Intel[®] Mobile Celeron[™] Processor at 466 MHz, 433 MHz, 400 MHz, 366 MHz, 333 MHz, 300 MHz, and 266 MHz Specification Update

Release Date: March 2000

Order Number: 244444-013

Figure 2. Workaround Flowchart: SMBALERT#-Driven System

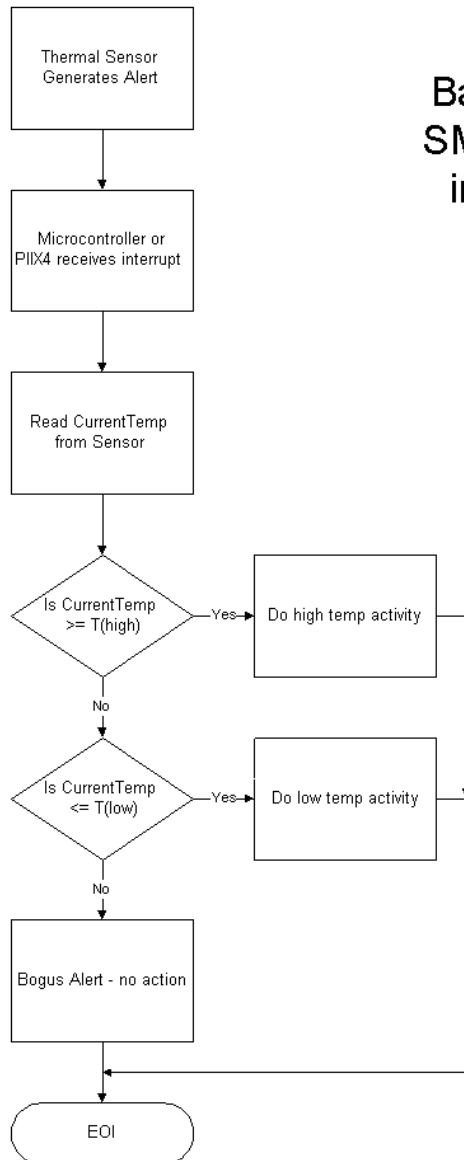
Workaround: Remove any one of the five conditions listed above or:

Figure 5.4. Surface-Mount BGA1 Package—Bottom View

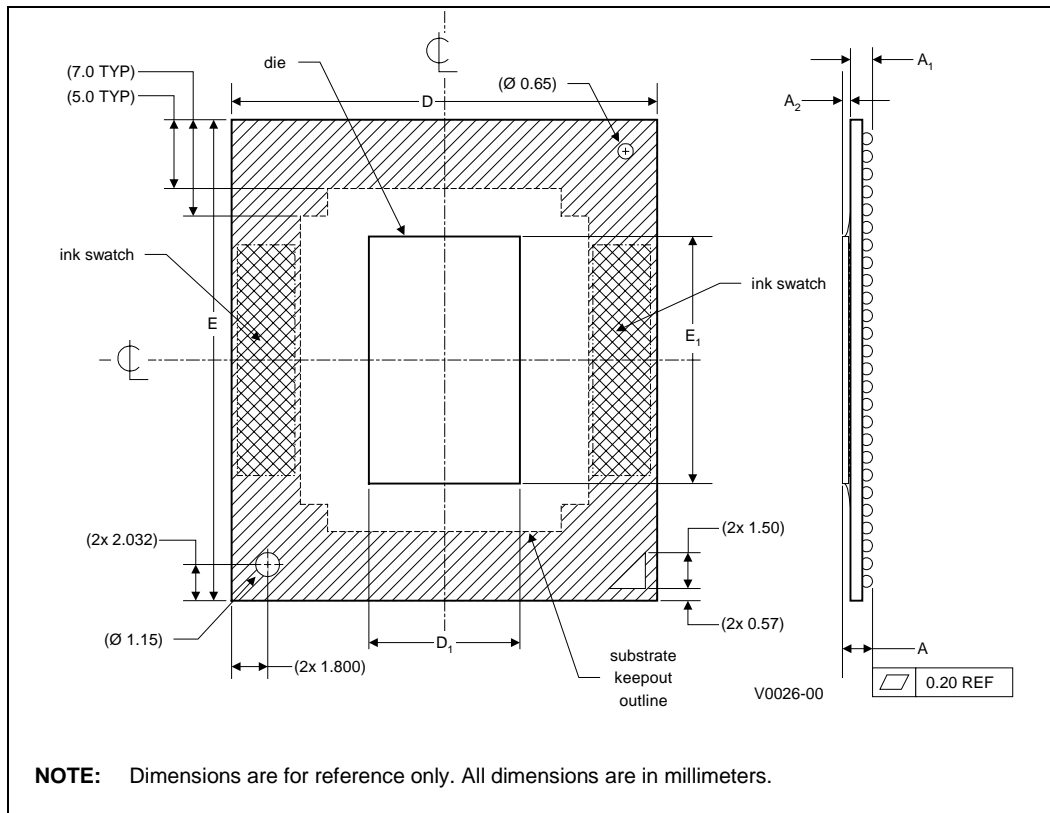
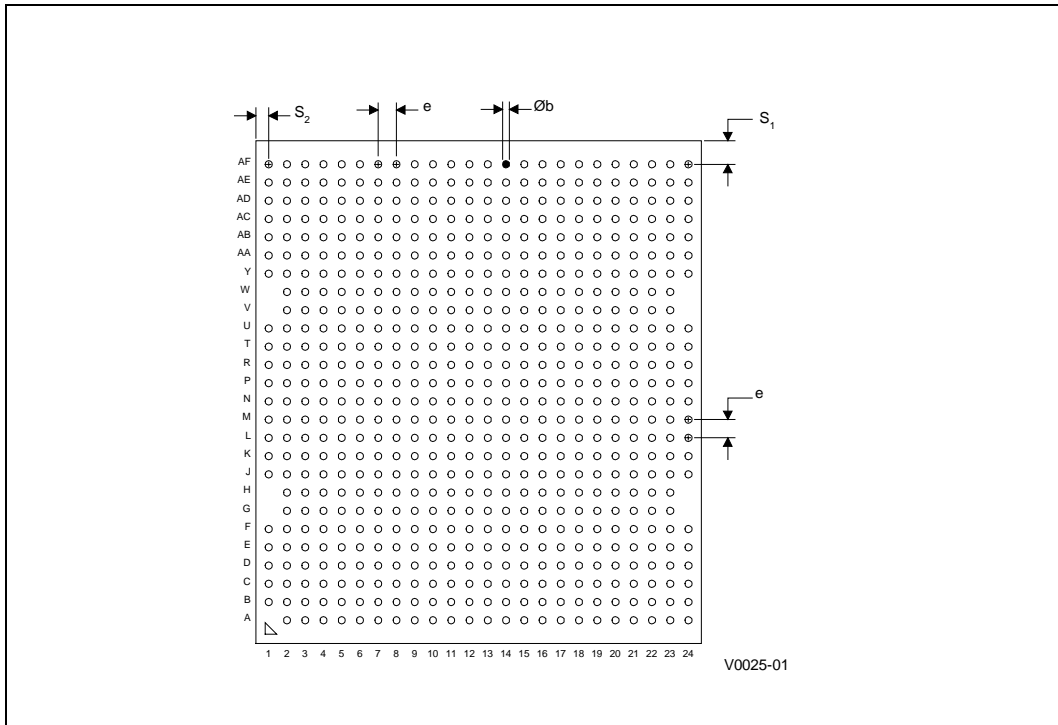
The following table and figures show the updated mechanical specifications for the BGA1 package, listed as Table 5.2, Figure 5.3 and 5.4, respectively, in the *Intel® Mobile Celeron™ Processor in BGA Package at 333 MHz, 300 MHz and 266 MHz* datasheet.

Figure 3.3 Generic Clock Waveform

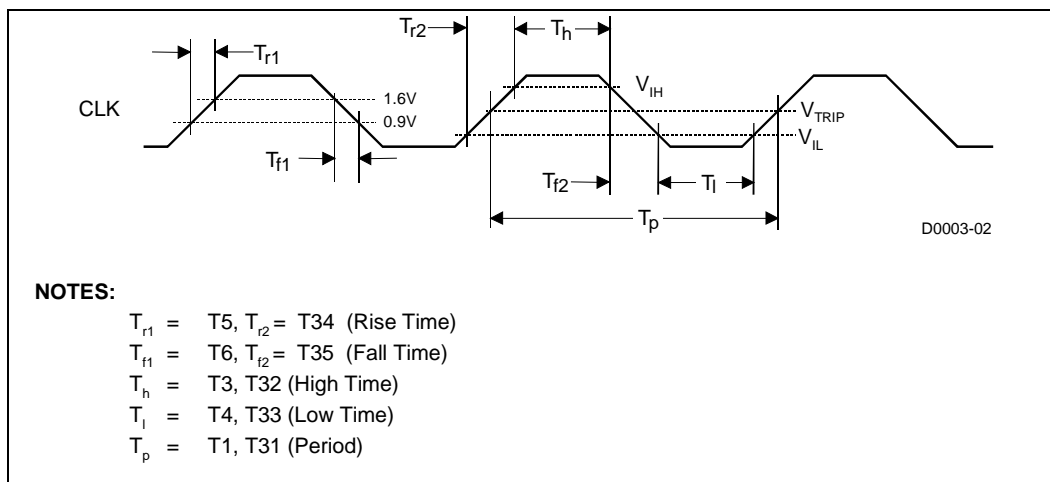
H11. Generic Clock Waveform Figure

Figure 3.3 in the *Intel® Mobile Celeron™ Processor in μ PGA1 and BGA1 Packages at 366 MHz, 333 MHz, 300 MHz, and 266 MHz* datasheet (Order Number 245112-003) has been updated. The following figure is to replace the one in the above document.
